Campaign No. 2021010005, January 2021

SUBJECT: **Model 907 (Sprinter), Model Year 2019**  
Engine Hood & Headlamp Adjusters

**Shown on right LED high-performance headlamp**

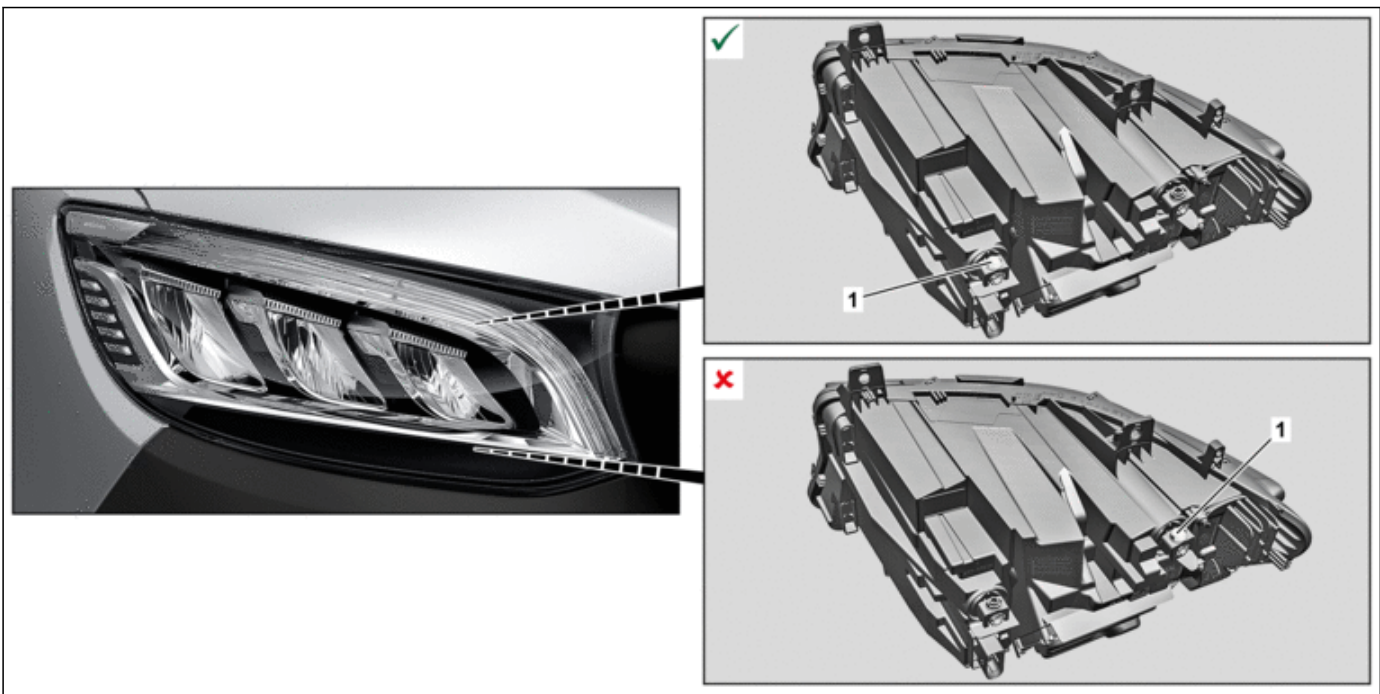
<b>Warning</b>	<b>Risk of injury</b> caused by fingers being jammed or pinched when removing, installing or aligning hoods, doors, trunk lid/rear-end door or sliding roof.	No parts of the body or limbs should be within the operating area when the components are moving.	AS00.00-Z-0011-01A
	<b>Check</b>		
1	Check, whether the vehicle is affected by the measure.	 For authorized Mercedes-Benz service partners, only the entry in the Extended VEGA Application (EVA) system, in the "Current" tab, is decisive. An additional test of the affected vehicles in the workshop information system (WIS) or vehicle list is thereby not necessary.	
2	Check installation position of cover cap (1) on headlamps at left and right.	If respective cover cap (1) is correctly installed on headlamps, ↓ continue with operation step 4. If respective cover cap (1) is not correctly installed on headlamps, ↓ remove affected cover cap (1) from adjustment screw for vertical adjustment of headlamp and attach to adjustment screw for horizontal headlamp adjustment (see picture for correct installation position). If the respective cover cap (1) on the headlamps is missing, ↓ attach new cover cap (1) to adjustment screw for horizontal adjustment of headlamp (see picture for correct installation position).

<b>Replace</b>		
3 	Replace engine hood.		AR88.40-D-3000TS
	<b>Check</b>		
4 	Check/correct position of headlamps.		AR82.10-D-1131TS
